# **Some Comments on Assembly and Performance of pre-series RE2/2 chambers**

With input and comments from colleagues in the ISR lab and PH-CMM

The 3 Chambers were received at CERN on the 2nd June 2005.

- HV connector.

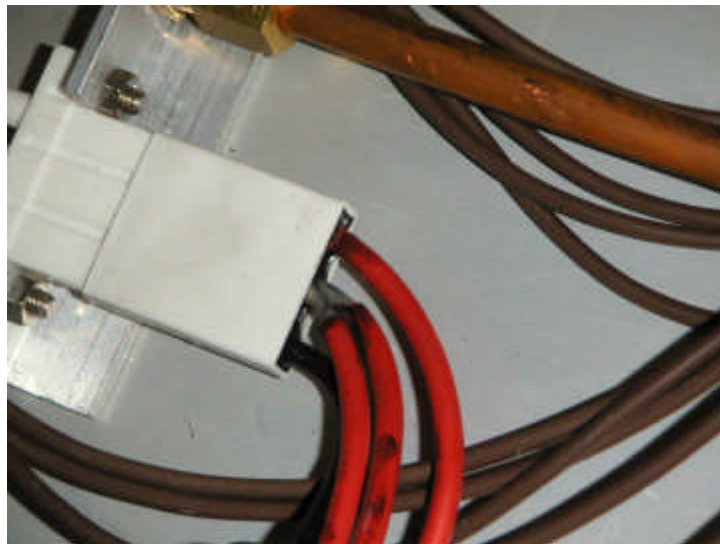
Great care must be taken in removing the insulation from the Cable leads. Here the insulation has been removed outside the connector, so compromising the HV breakdown strength.

Sharp edges could compromise the insulation of the Faraday cage Cu shield wrt the chamber structure. Tape (polyester) is a solution. Hot melt run along the edges is more laborious but gave some reasonable results requiring additional refining in the procedure.

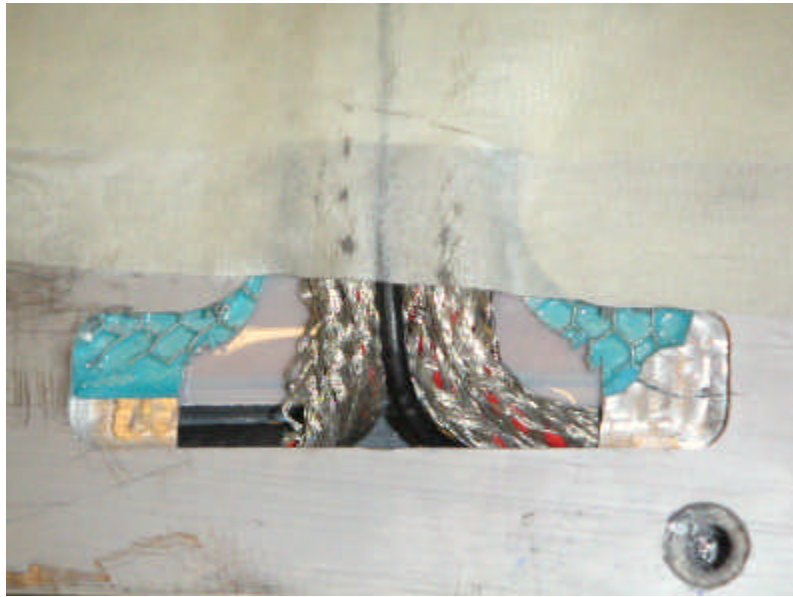
The opening for these cables is well calculated and executed.

Some of the 0V return lines for the gaps were of thicker section ( $2\text{mm}^2$ ) than those used on the RE1 chambers ( $0.75\text{mm}^2$ ). This makes cable routing more difficult, HV connector assembly is not possible with both wires and more critically it weakens the 0V connection on the gap. This is already a weak point and may explain the failure that we found. There is no solder on this failure! Similar failures have occasionally been identified on RE1 gaps.

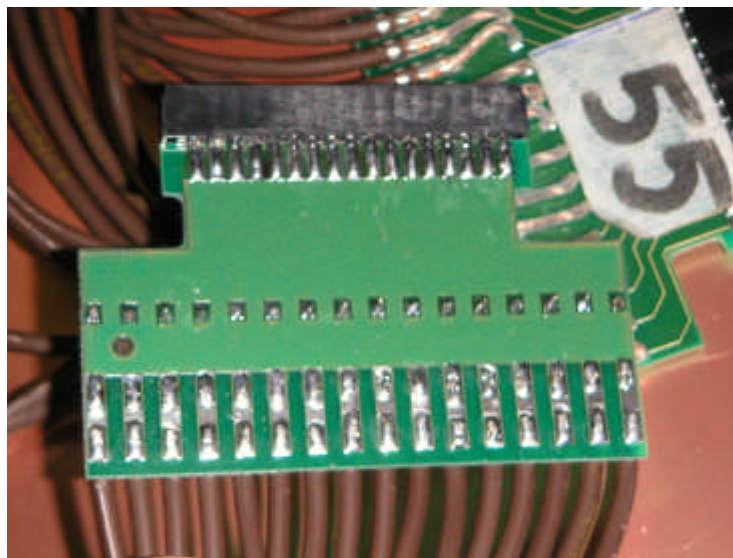
The soldering to the strips ( 35 $\mu$ m Cu ) is generally good but there is room for improvement in consistency.

The cut out to access this solder point is a better concept than in RE1

The soldering to the adaptor boards appears well done .

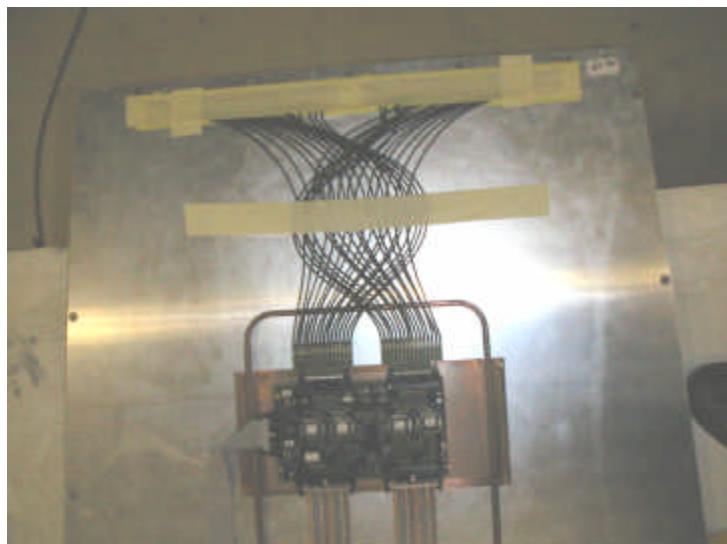
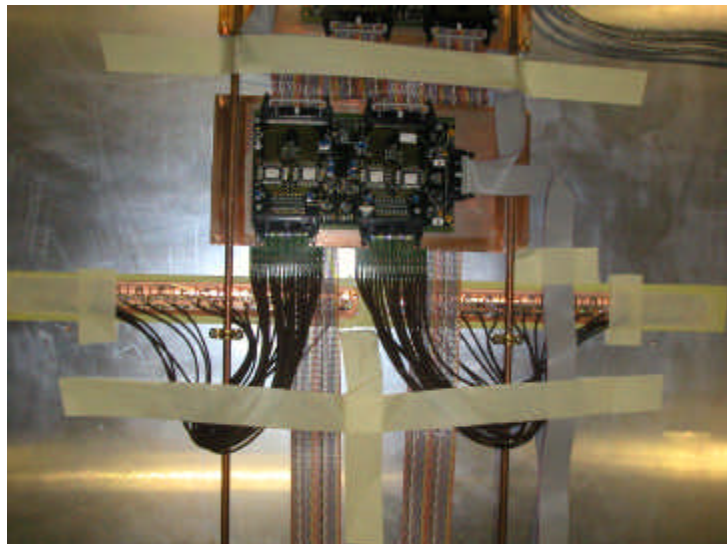
We recommend revisiting the routing to obtain a more repeatable result as illustrated below on these RE1 chambers.

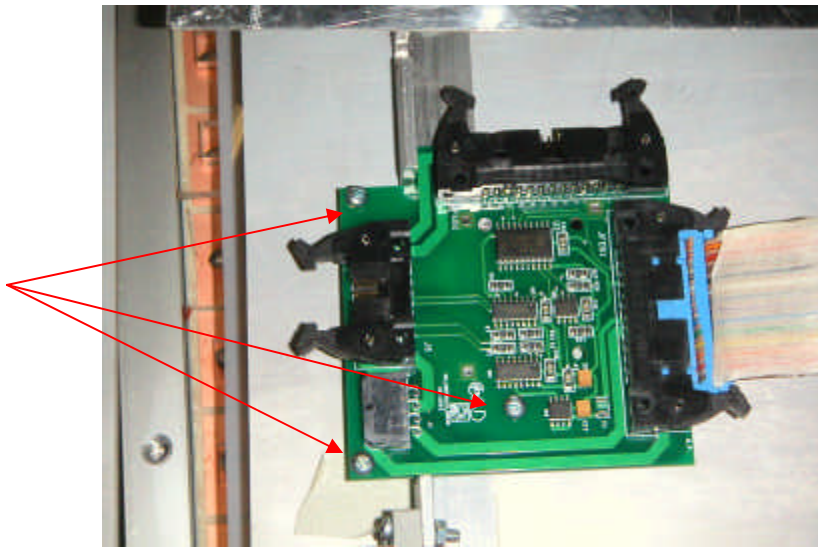
The LV Distribution Board was not fitted to these three pre-series chambers . This should be secured directly to the HCP using small and short (!!) self tapping screws. A similar solution works extremely well on RE1 for securing the small Alu panels covering the coaxial cables outside the shield box. Here 8mm long PA stand-offs have been envisaged with self tapping screws of 2.9 x 13mm. The lower screw will require an insulating washer as it is very close to a conductor trace.

Little advantage can be obtained by folding the cable at a traditional 90 degrees. Here a slight reduction in length is obtained with a consequent lose in esthetic appeal !

The use of twist and flat cable for the power cables imposes 50cm cutting intervals. A flat untwisted cable is adequate and easier to install as the length is not constrained to discrete values. They should be kept, where possible, away from the signal flat cable.

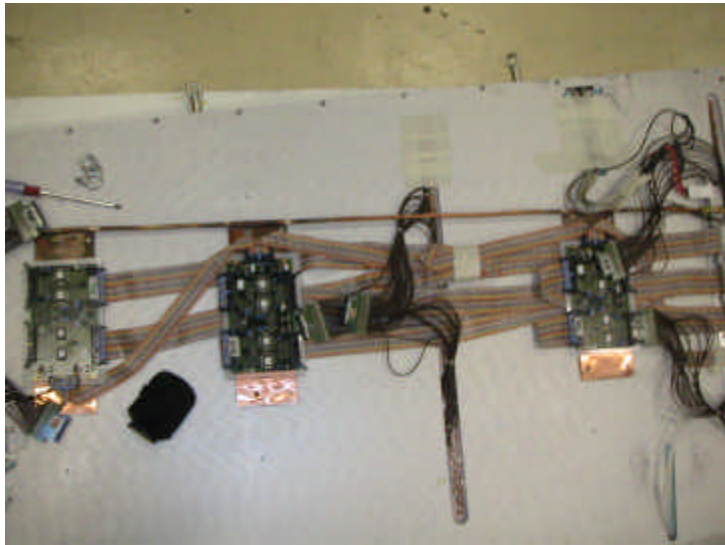
The placement of the FEB can be offset in phi so as to obtain parallel paths for the flat cables with no crossover and little excess length. This is the reason why the Cu cooling plates are so 'wide' in phi.

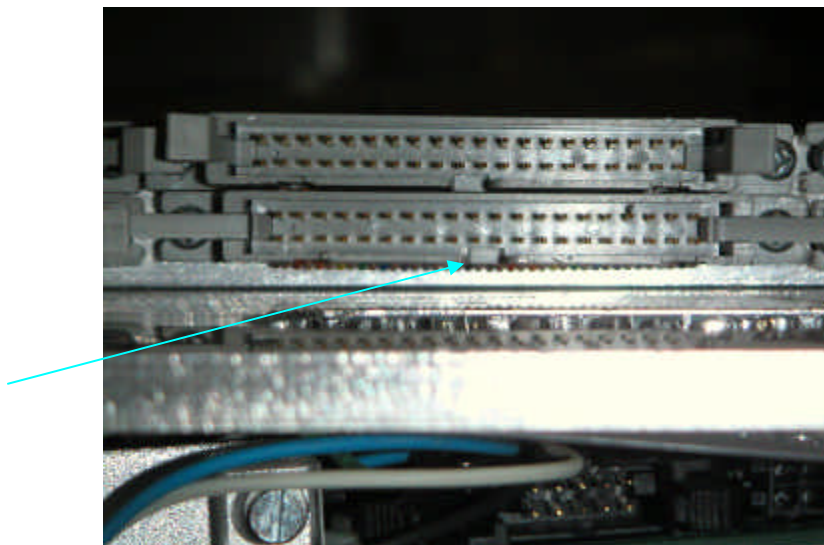
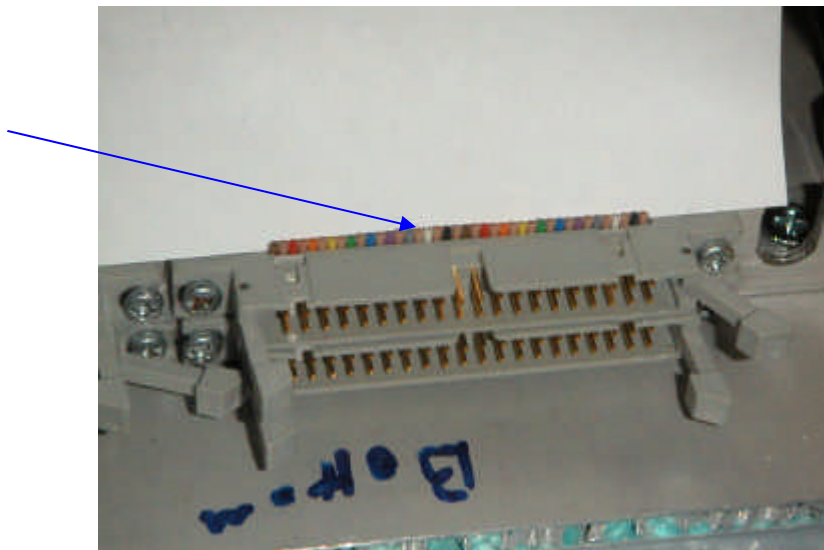
The cable should be cut off flush with the connector as in some cases shorts could occur. Possibly to the HCP or an adjacent connector.

Crimping of the connectors is most important as this will influence reliability and operational life time. Care must be taken and the operation followed closely.

The routing of the flat cables is not trivial and if at all possible must agree with those chambers already made, namely RE1. This is necessary as the read out is entirely dependant upon the cable routing and consequent connector layout on the patch panel.

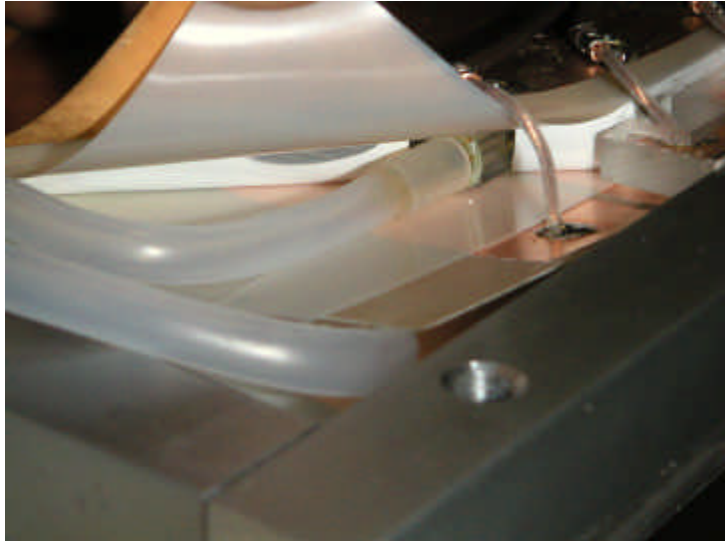
The connections to the gaps seem to be well done. Heat should be used in moderation if not the insert can be weakened.

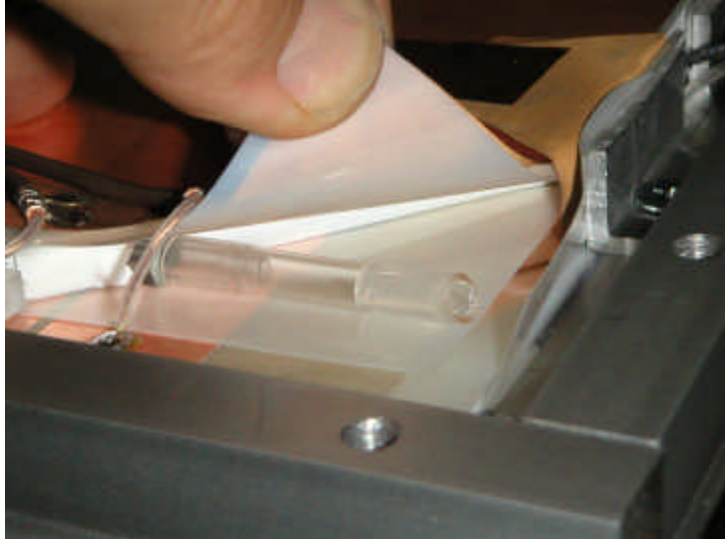
Plugging up of the unused gap connexions should preferably be done with the PE pipe used else where and not PVC. The PVC will resist chemically but may be more liable to hardening in time.

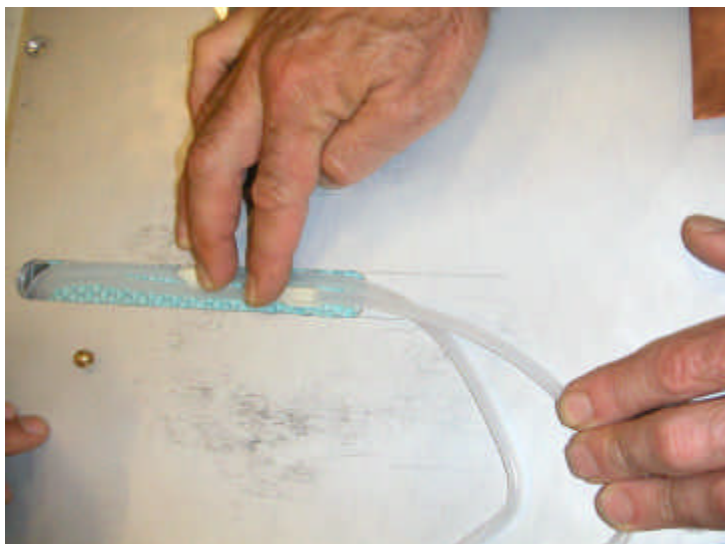
The cut outs in the panel are not deep enough and so leave a rough surface for the pipes to be damaged upon. Taping, remilling or filling with a low viscosity caulking compound should be considered.

The routing and thermo forming of the gas pipes must be done so that the routing is facilitated. This is not such a good example. Numerous iterations will be needed to obtain a good repeatable result. Tooling is essential for each model of pipe.

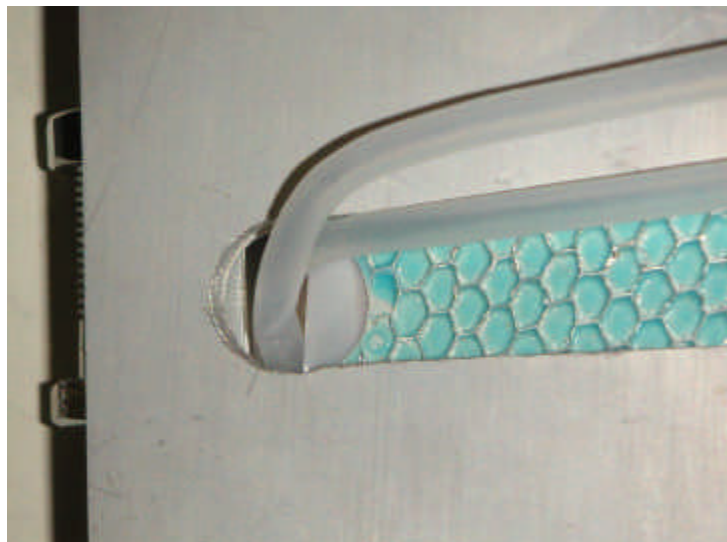
Coming back to cut outs, here the gas pipe can easily be kinked if the hole is too small as is the case in the picture below. (The HV cutout is a good example ). Flow should not be obstructed. The kink will be unlikely to relax and alleviate the problem

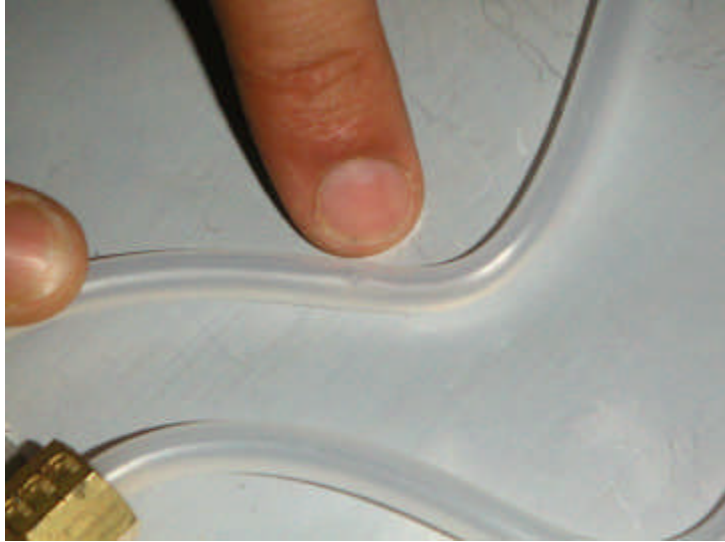
The pre-forming of the pipes must be done according to a pre-established method, using standard tooling (to guarantee the right temperature for the correct length of time). In the case illustrated, the pipe has melted and is damaged.

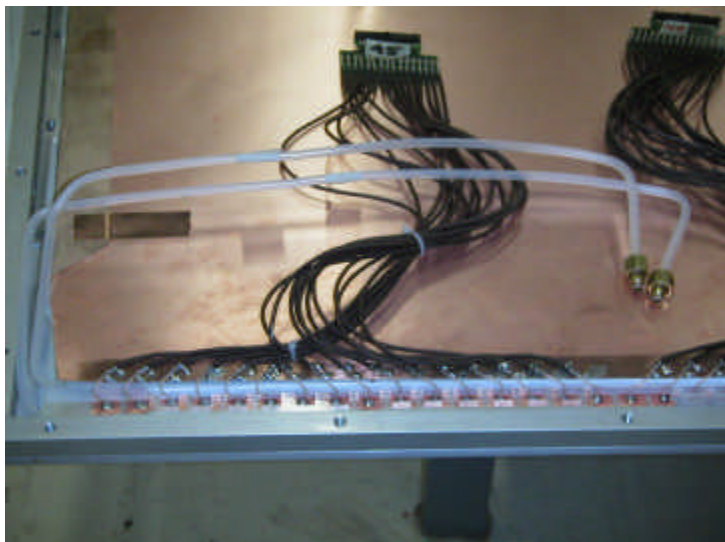
The routing has to be simplified, avoiding unnecessary crossovers

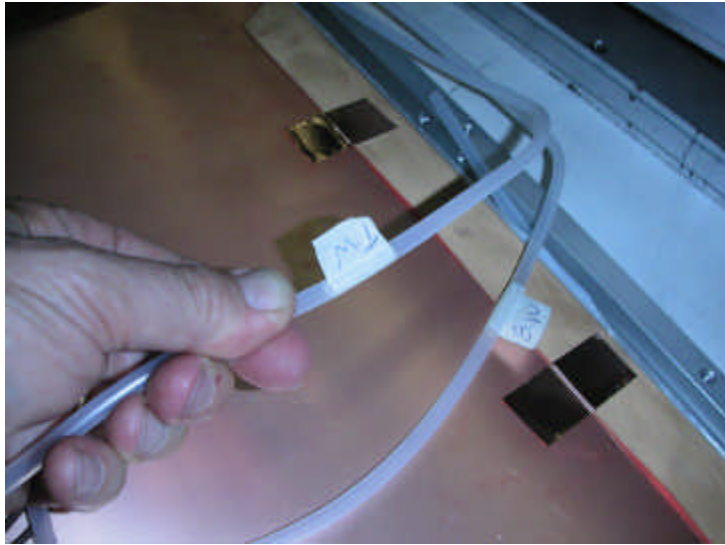
Labeling the pipes is good practice to prevent mistakes.

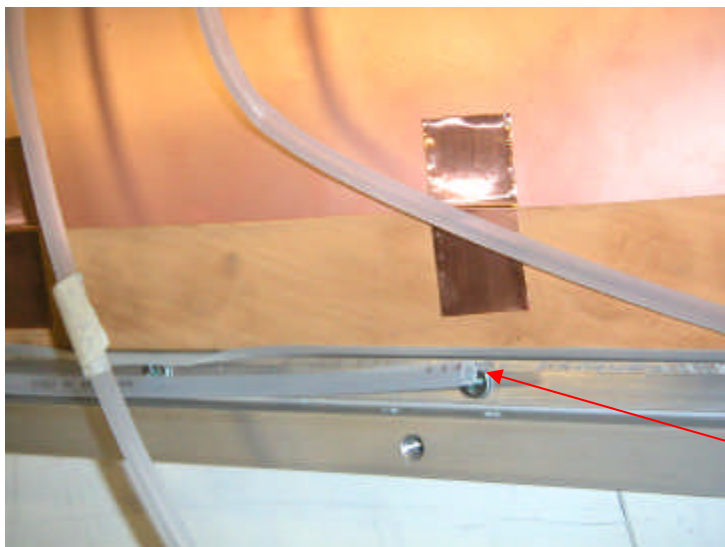
Leaving spare pipe in the chamber is not really useful.

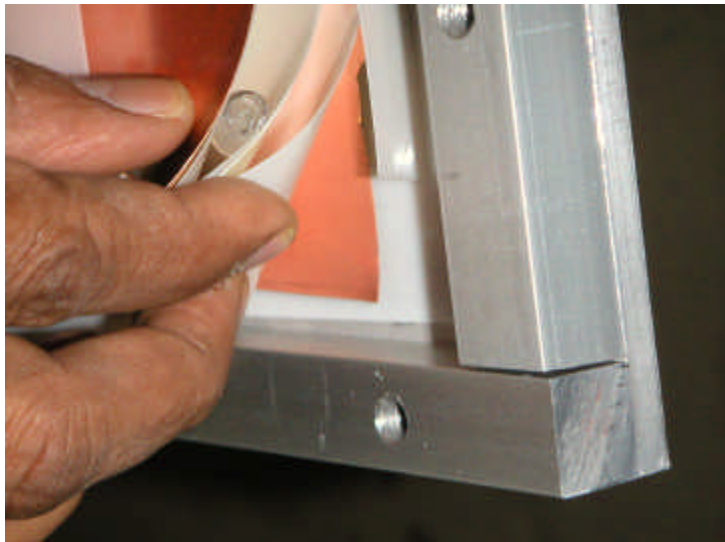
The bottom copper foil must be insulated from the chamber chassis. Since the chambers are vertical the copper film may shift, thus the edges should be insulated with tape. Tape used to retain pieces in place during assembly is insufficient. Some additional positive location is needed.

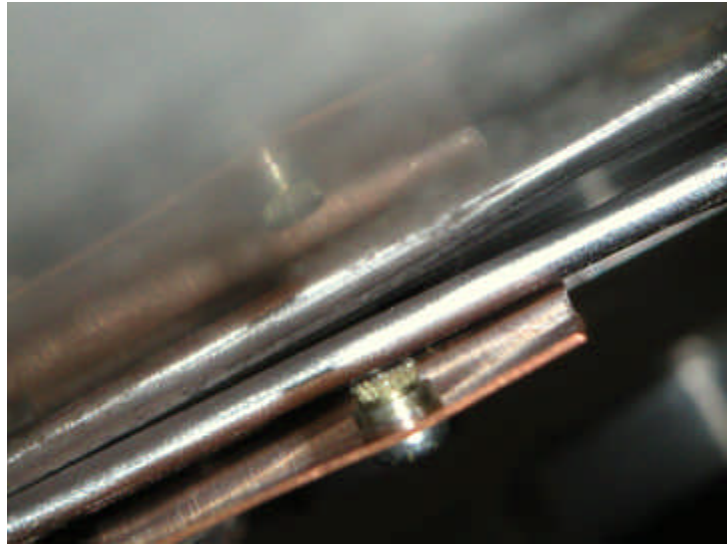
- The FEB should be mounted in a secure manner to the copper cooling system. It is electrically insulated from it.

The spacer necessary should be kept to a minimum so as to keep overall thickness of the chamber to a minimum. This one can be reduced to the thickness of 2 flat cables.

The rigidity of the assembly could be improved .

The very small plastic screws used in attaching the FEB to the cooling plate are fine but insufficient in number (2) and tightness. There must be 3. The holes have to align somewhat better. Mounting the male part to the Cu sheet is a good idea and ensures an easier assembly than in RE1.

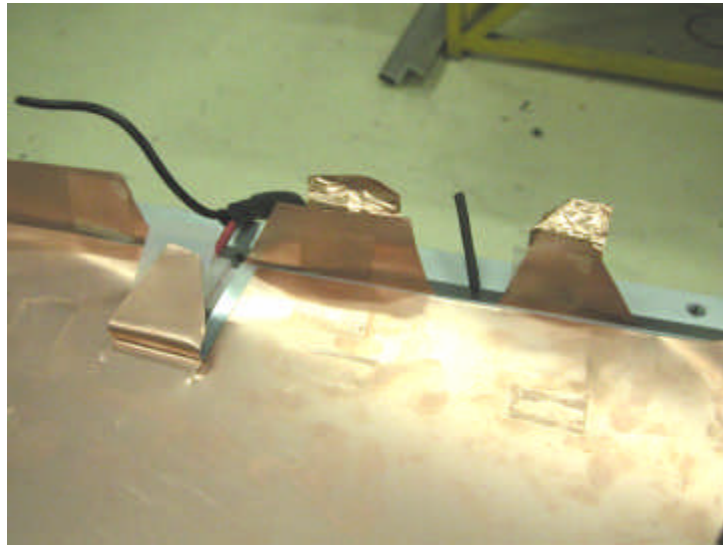
The use of double stick is not sufficient to ensure electrical conductivity in building a Faraday cage but of course it does ensure a close proximity of the two Cu sheets which is also a pre-requisite of same. The tape was tested to be nonconductive.

Soldering of small points along the edge are a good addition to ensure good long term conductivity, once thinner copper sheet is available.

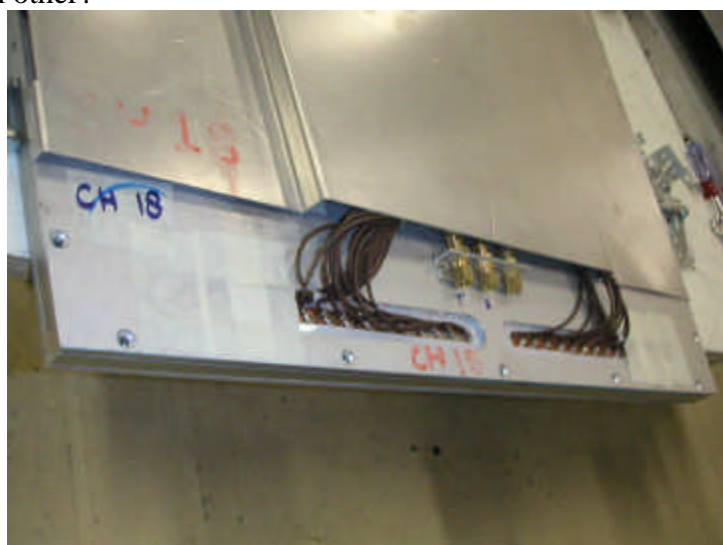
Can the bottom patch panel be reversed so that the cooling and gas pipe do not crossover each other?

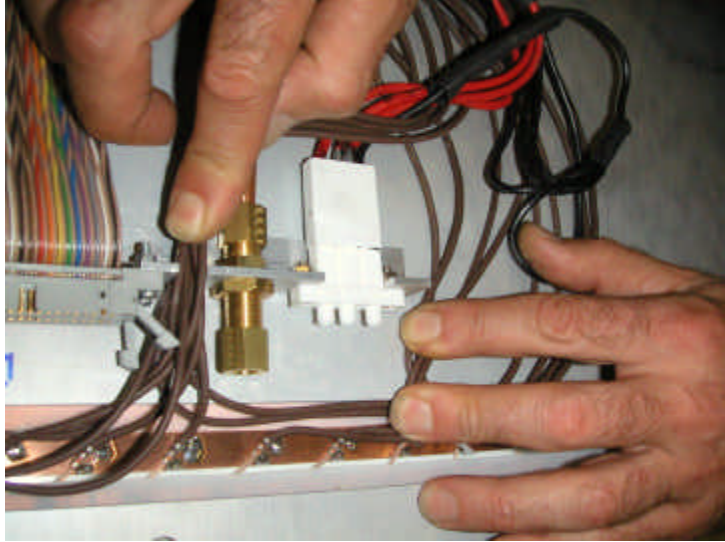
However at the outer 'R' end the situation is more complex. Here the obstruction/hindrane of connectors appears to be a problem. The solution may be to redirect more coaxial cables through the slot already milled next to the cooling union., as shown.

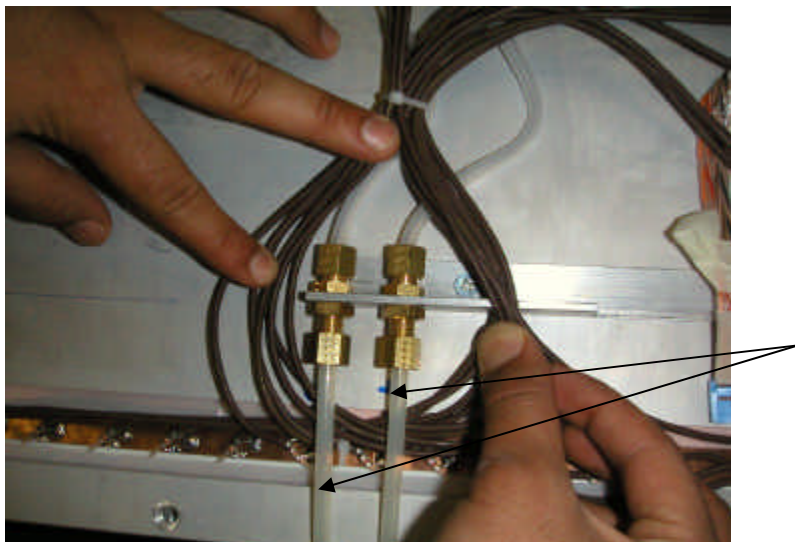
A similar argument can apply to the other side. Note the external gas pipes.

All unions and their respective lock nuts must be tight, otherwise twisted gas pipes and leaks can result.
